**Project Name: USC Horseshoe Utility Brick Repair**  
**Project Number: FP00000070**  
**University of South Carolina**

**Addendum Number Three**

Date: May 17, 2018

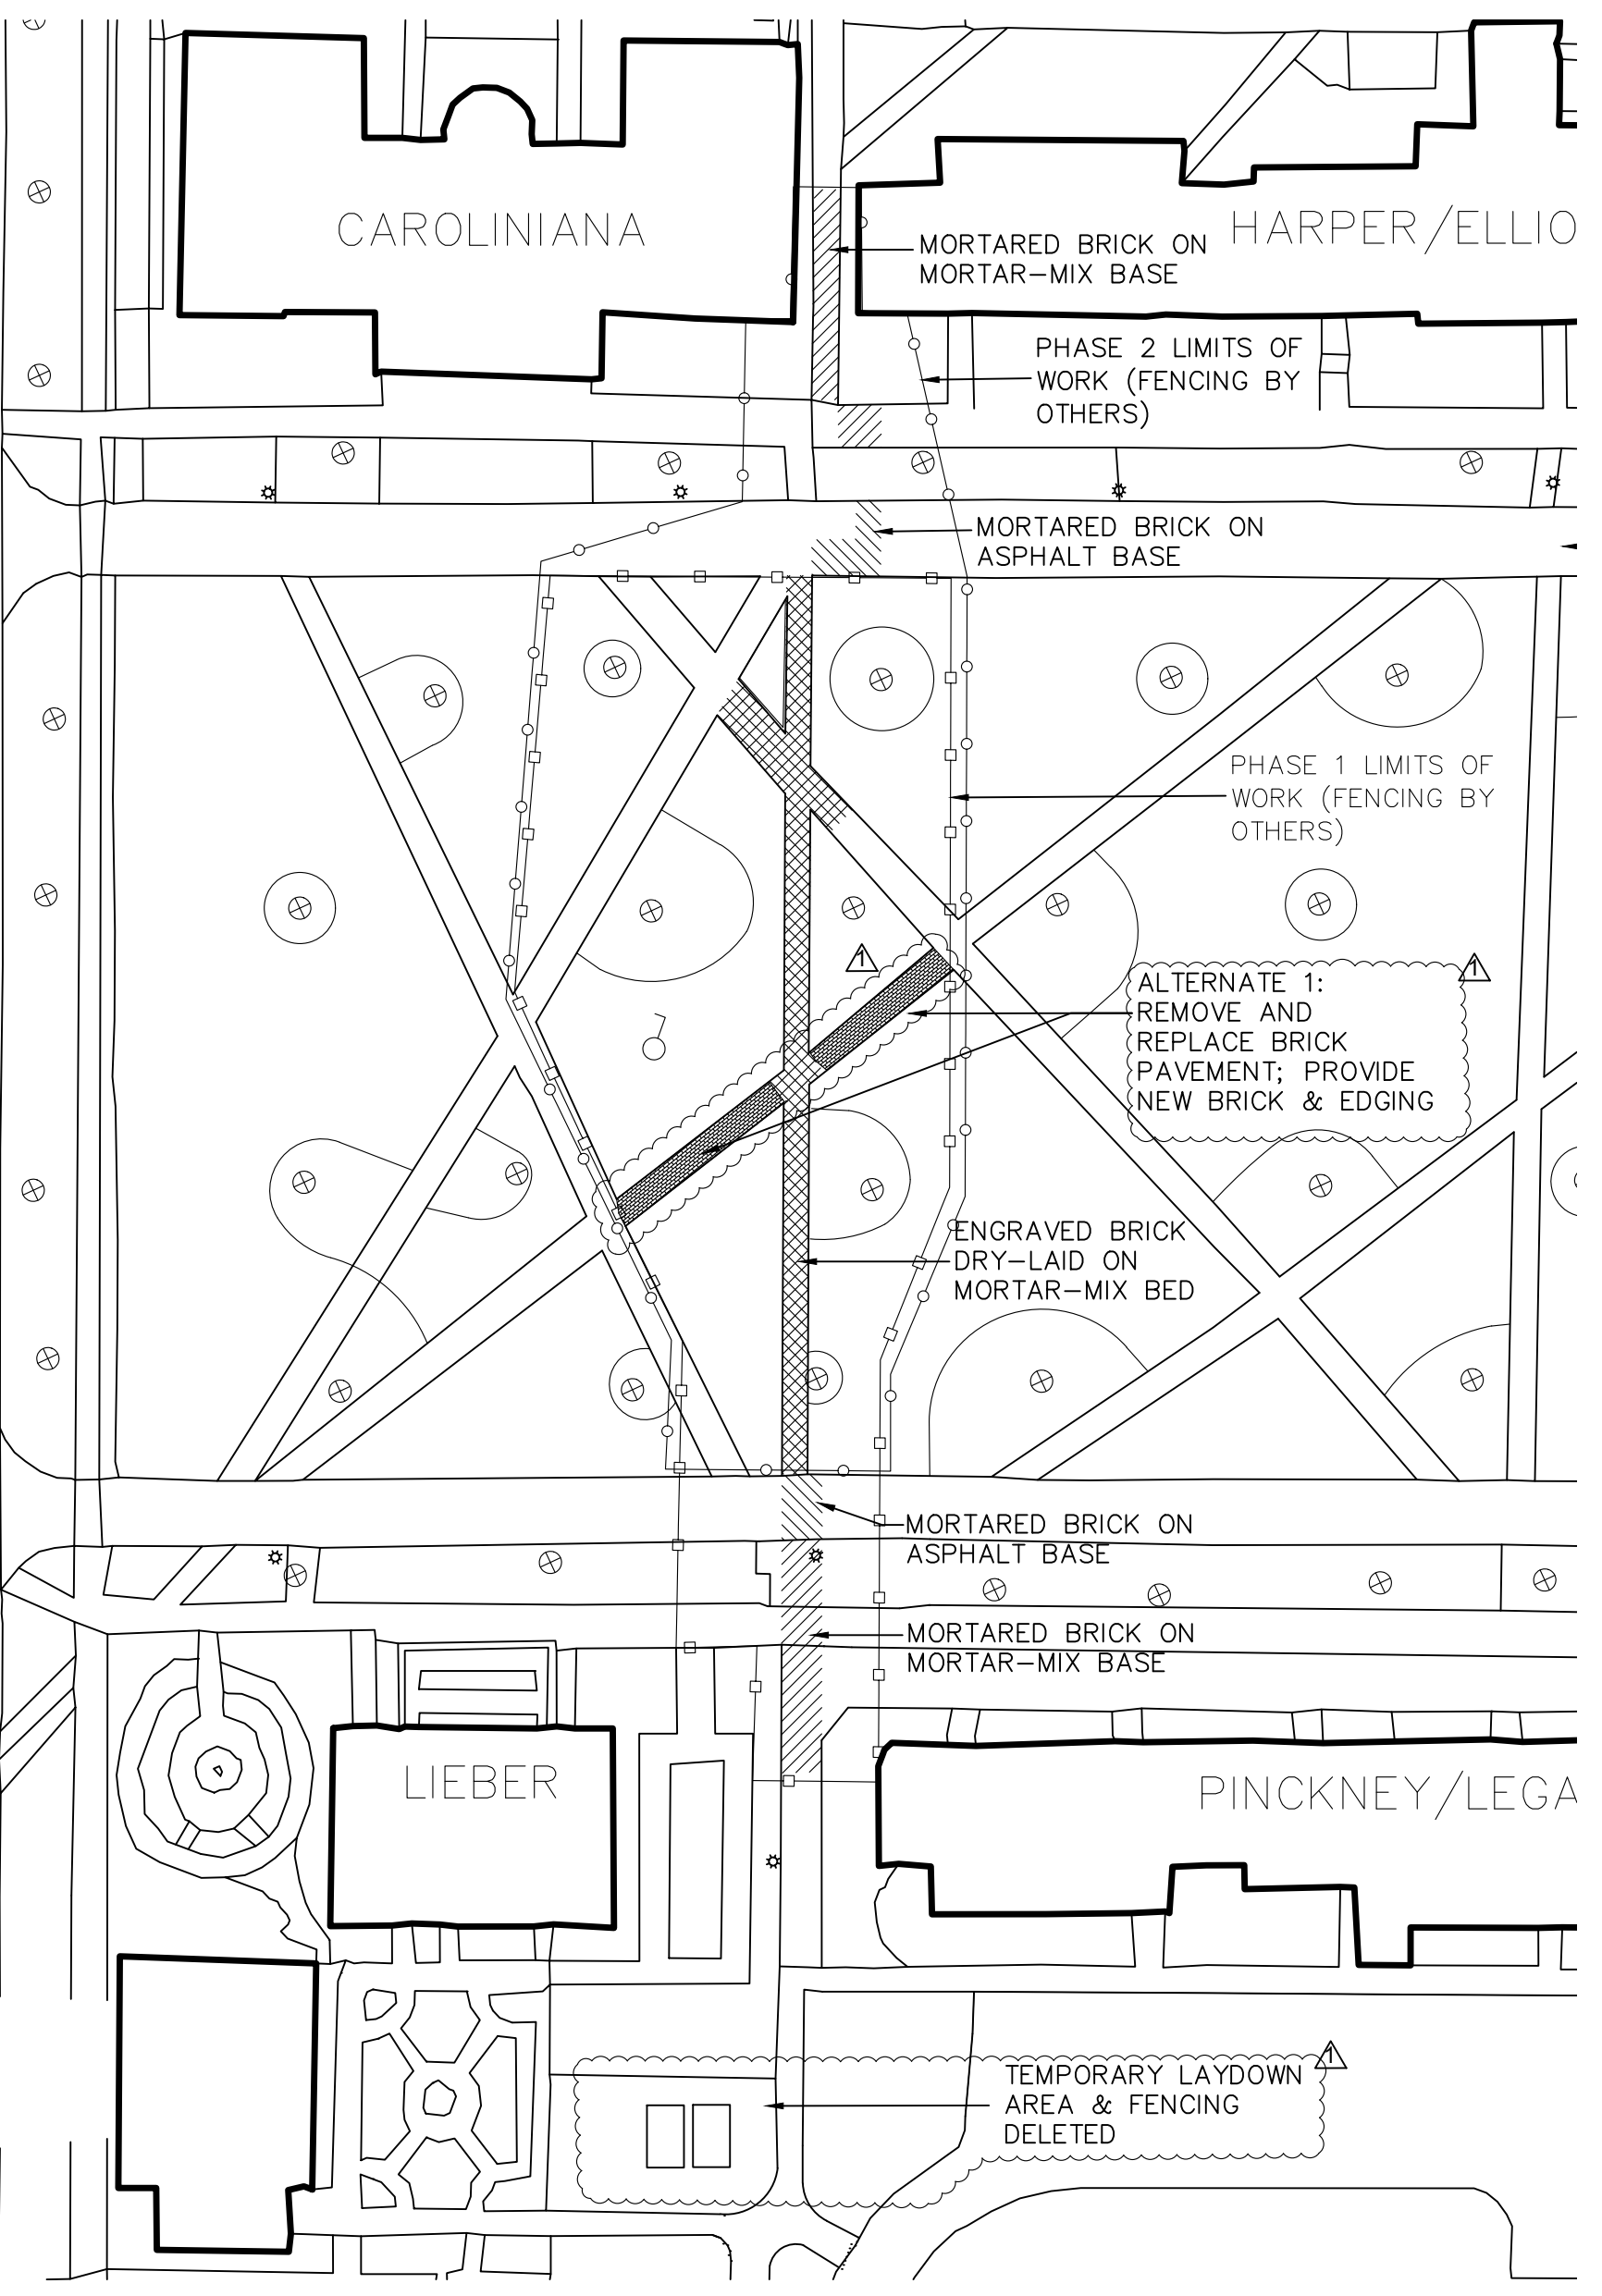
2. Reference Sheet L-1. Replace with the attached revised Sheet L-1 dated 5.17.18. Bidders shall price as Alternate One (1) the additional removal and replacement of approximately 100 LF of brick sidewalk within the project area as shown on each side of the primary area of repair. New brick shall be provided and installed by the contractor using 'Pathway Red 4x8', by Pine Hall Brick, laid following the detail for "Engraved Brick Pavers" on sheet L-2. Site preparation by the contractor shall include removal of existing base material and subgrade to provide a 6" crushed stone base. Pattern shall be a modified basket weave. Provide black or brown aluminum angle edging.

4. The temporary laydown area with fencing requirement has been deleted. Laydown space will be provided within the existing fenced area of the utility project.
